COMPANY: Multi-purpose Clock board			
TITLE:			
CODE:	SIZE:	DRAWING NO:	REV:
SCALE:			SHEET: 1 OF 1

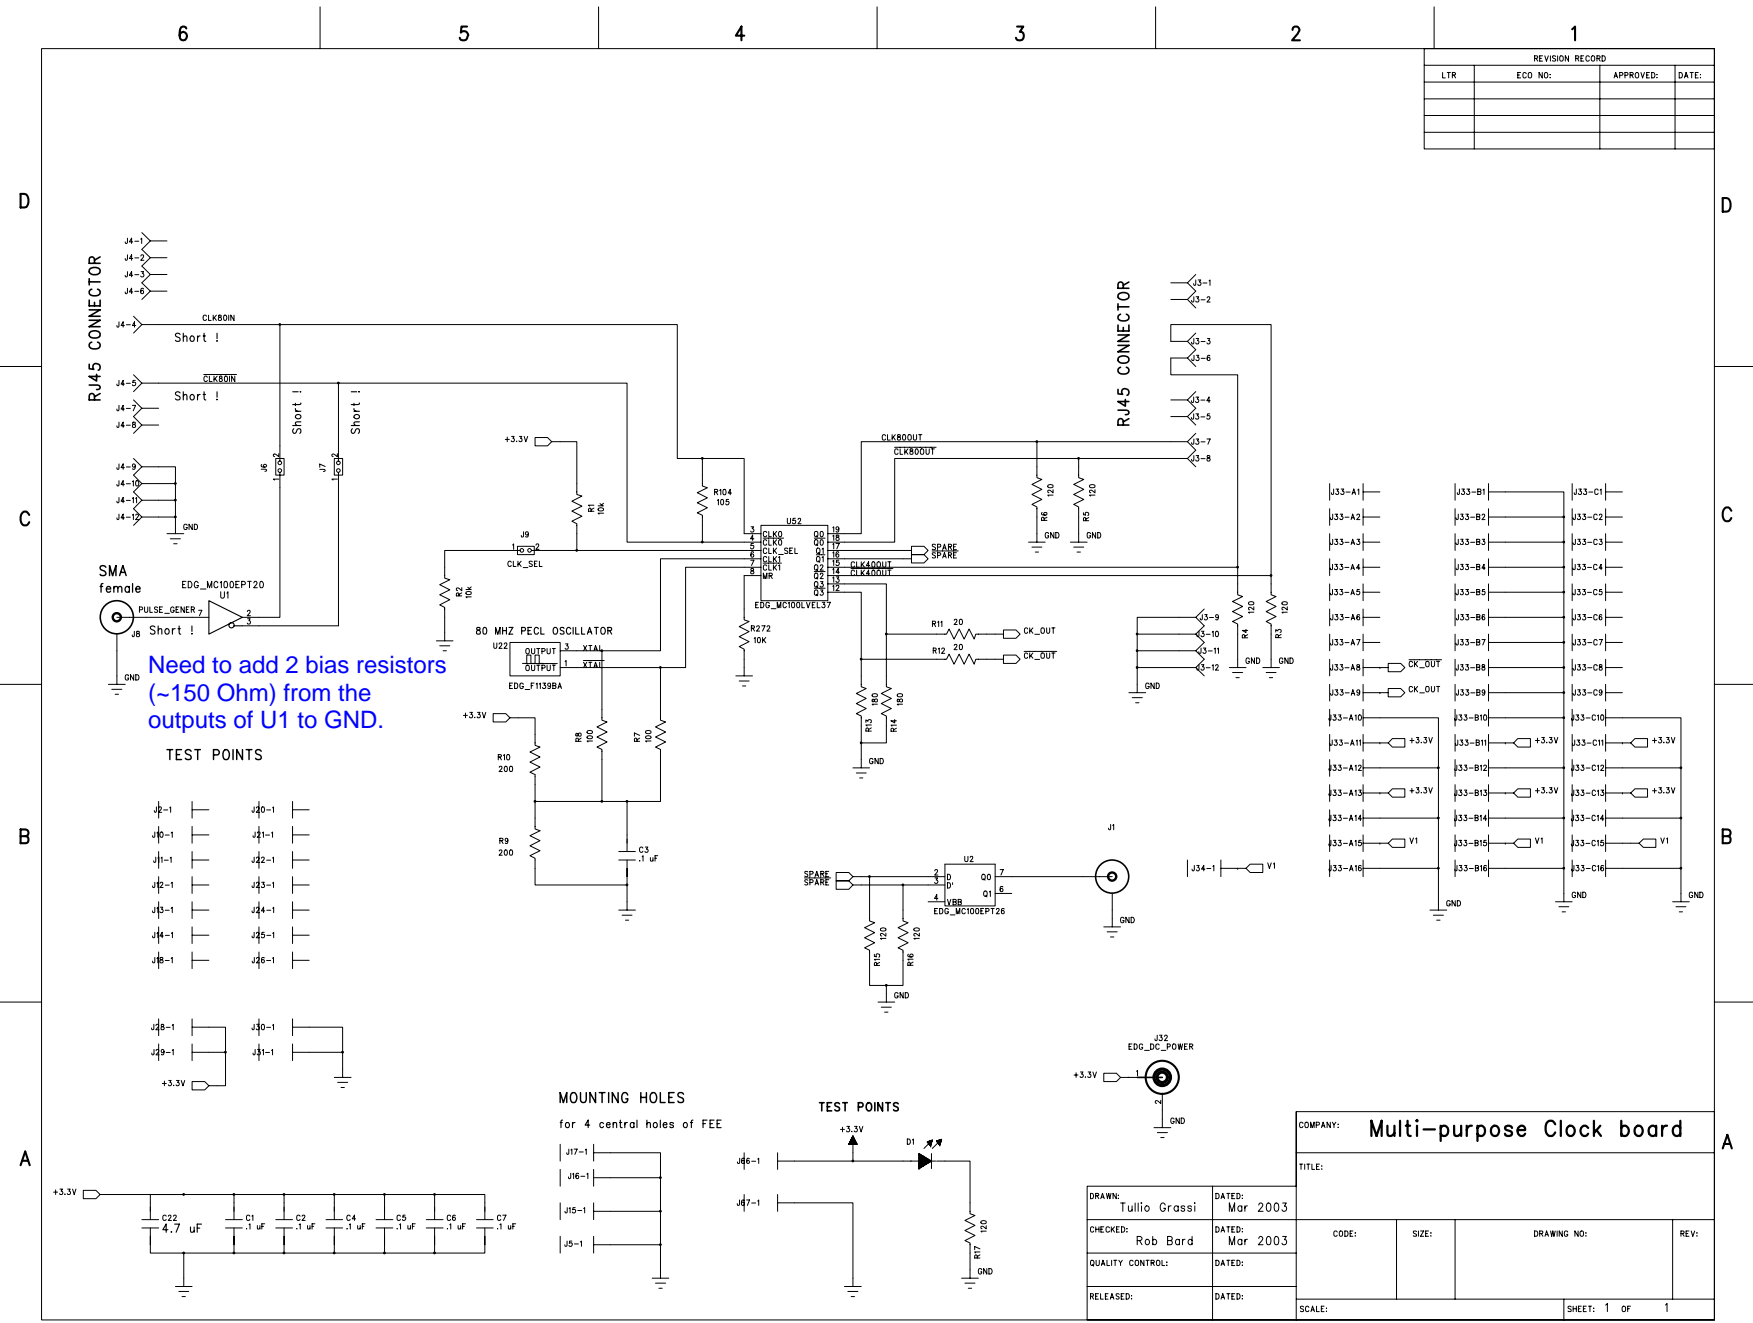
Need to add 2 bias resistors (~150 Ohm) from the outputs of U1 to GND.
